March 31, 2011

Subject: UniStar Nuclear Energy, NRC Docket No. 52-016  
Response to Request for Additional Information for the  
Calvert Cliffs Nuclear Power Plant, Unit 3,  
RAI No. 268, Stability of Subsurface Materials and Foundations

**RAI 268 Questions 02.05.04-26 and 02.05.04-27,  
Stability of Subsurface Materials and Foundations**

**Calvert Cliffs Nuclear Power Plant Unit 3**

**Figure 1**  
**Representation of the Mesh for the Four Settlement Models**

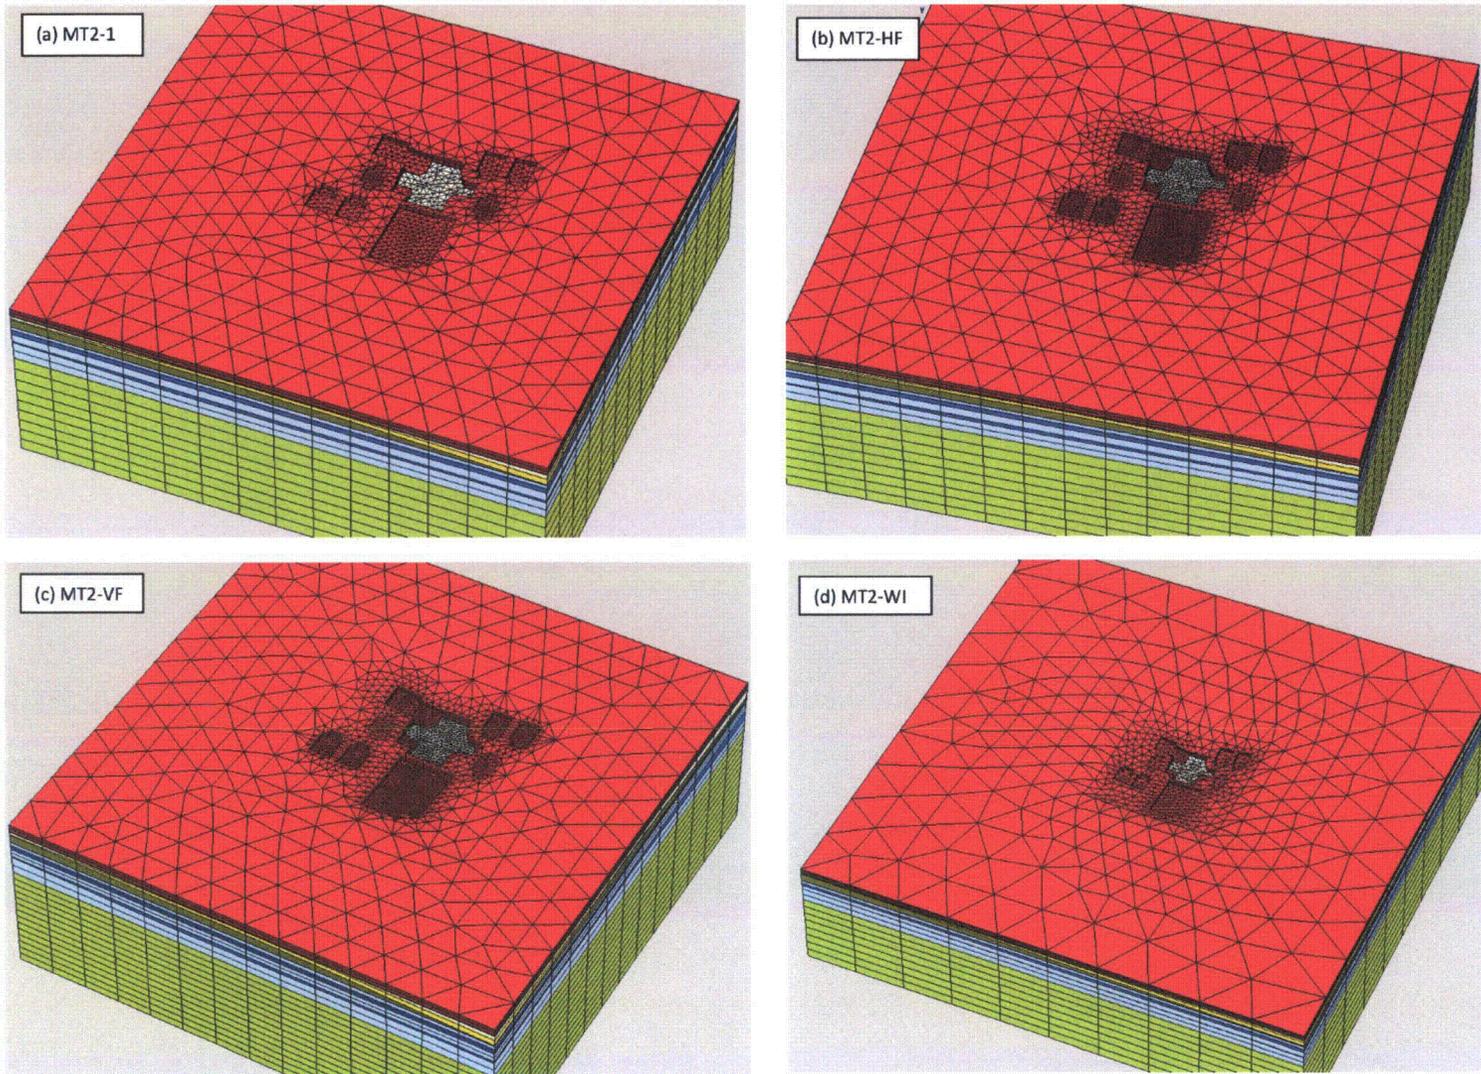
2. For both the MT2 and SH models analyses, discuss a) the adequacy of finite element mesh size, which can affect the plastic model analysis results; b) the effect of distances between the edge of the foundations and the fixed boundary elements; and c) the effect of non-uniform loading conditions.

The MT2 and SH models have 42,130 and 88,124 elements, respectively. The effect of mesh size on the settlement estimate is checked by changing the mesh of the MT2 model. Both the SH and MT2 models can account for the possible plastic states and the SH model mesh already has a higher number of elements with a finer mesh. To address the adequacy of the mesh refinement and the distance from the edge of the foundation to the lateral model boundaries, four models were created as shown in Table 1 (MT2-1, MT2-FV, MT2-FH, and MT2-WI models). The representation of the models is shown in Figure 1.

The MT2-1 model has the same mesh and model dimensions as the FSAR MT2 model. For the purpose of the comparison of settlements that result from evaluations with models of different mesh sizes, the end-of-construction loads were applied in one step and the primary loading elastic modulus was used instead of the unload/reload soil modulus.

Table 2 indicates the variability in the settlement results underneath the footprint center of each building. The impact of the mesh refinement is negligible, which indicates that the element size and configuration of the MT2 model is adequate and computationally optimal. The maximum difference in settlement of the models with respect to MT2-1 model is less than 1 percent.

The settlement obtained from the MT2-WI model is less than 1.4 percent different from the settlement obtained from the MT2-1 model for any building on the CCNPP Unit 3 site. Therefore, the distance between the edge of the foundation and the fixed boundaries for the MT2 and MT2-1 models, as well as for the SH model, is adequate.

In conclusion, the implemented finite element mesh and model dimensions have been optimized for computational efficiency and are adequate representations for settlement estimation purposes.

**Figure 2**  
**Idealized Soil Profile and Load**

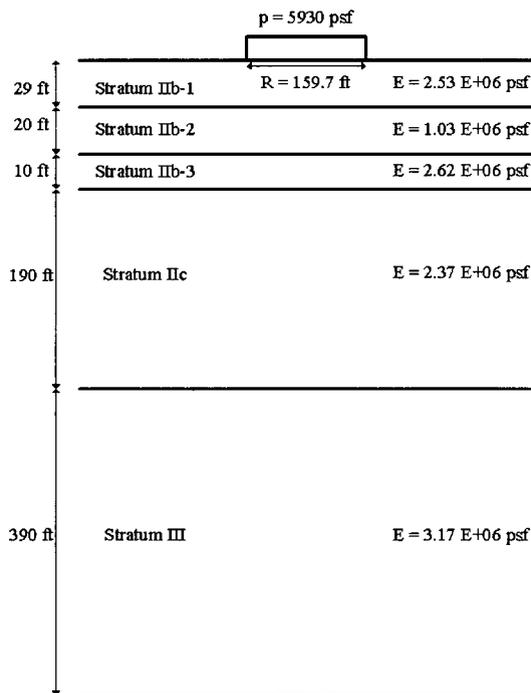
- a) Provide references that support the statement, "both theory and experience have shown that the shape of the pressure bells (induced stress distribution) is more or less independent of the physical properties of the loaded subsurface" for layered soil since it is well known that the Boussinesq solution is an elastic solutions based on assumptions of load acting on a weightless material in a linear-elastic homogeneous isotropic half-space and not subject to initial stress. Experience has shown that the

In addition to the reference provided, additional analyses have been performed to assess the adequacy of the stress values beneath the building facilities. To support this discussion, a summary of soil parameters is provided in Table 5 and an idealized soil profile is provided in Figure 2. Note that the depth of the foundation is 41.5 ft.

Table 6 provides a comparison of the stress/load ratios at different elevations for both solutions along with the Boussinesq values. The agreement between the different approaches indicates that the Boussinesq solution can be used to estimate stresses for the settlement hand

**Figure 3**  
**Soil Profile and Approximate Settlement Percentages by Layers**

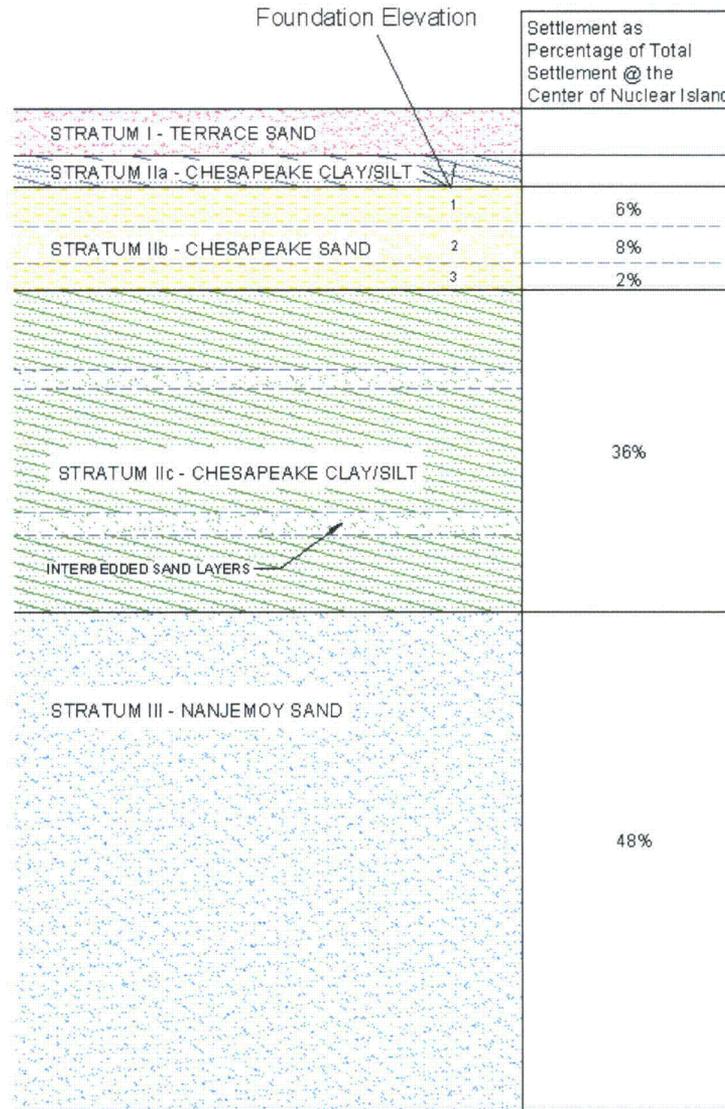
1. Given the non-linear character of the soils at the Site (as evidenced by the tri-axial tests results), justify the adequacy of the soil models used in predicting settlements for the CCNP site in the FSAR.

2. Given the wide range variation of consolidation properties for the tested soils and a lack of data sufficient to establish a verifiable spatial correlation of the properties, provide an assessment of how large differential settlements will be incorporated into the design of the NI structures given the relatively small differential settlement allowances in the standard design.

Figure 3 below is a broad interpretation of the soil profile at the CCNPP site and is used solely as a reference when considering the various triaxial and consolidation tests.

The right side of Figure 3 provides the rough percentage of the total settlement attributed to Stratum IIb, Stratum IIc, and Stratum III. It is noted that about 84 percent of the settlement is associated with consolidation of the Stratum IIc - Chesapeake Clay/Silt and the Stratum III - Nanjemoy Sand. Therefore, the focus is the best models applicable to these two Strata, the field data for these two strata, and on the tests performed on samples obtained from these two strata.
